March 31, 2000

Telergy
Mr. Randy Smith
Manager – OSP Engineers
7351 Round Pond Road
N. Syracuse, NY 13212

This letter is in response to your letter dated March 24, 2000, concerning attaching to the opposite side of the pole. During our phone conversation on March 23, 2000, we suggested as a first alternative using the opposite side of the pole (where practicable) for your attachment. We did not suggest that you continue to use the proposed bracket utilizing the existing CATV thru-bolt.

Figure 3-1. Clearance Between Licensee-Owned and Telephone Company Cables

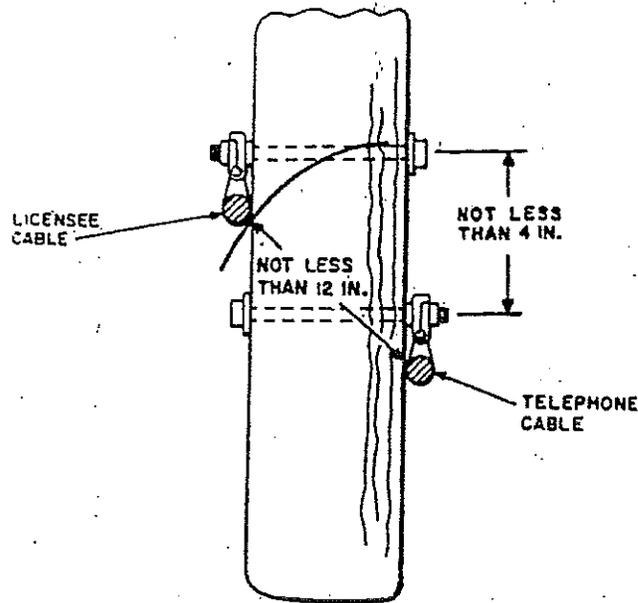
Niagara Mohawk suggests that Telergy attach their cable in accordance with section 3.07 of the Bellcore – Manual for Construction Procedures (Blue Book) as shown in Figure 3-1.
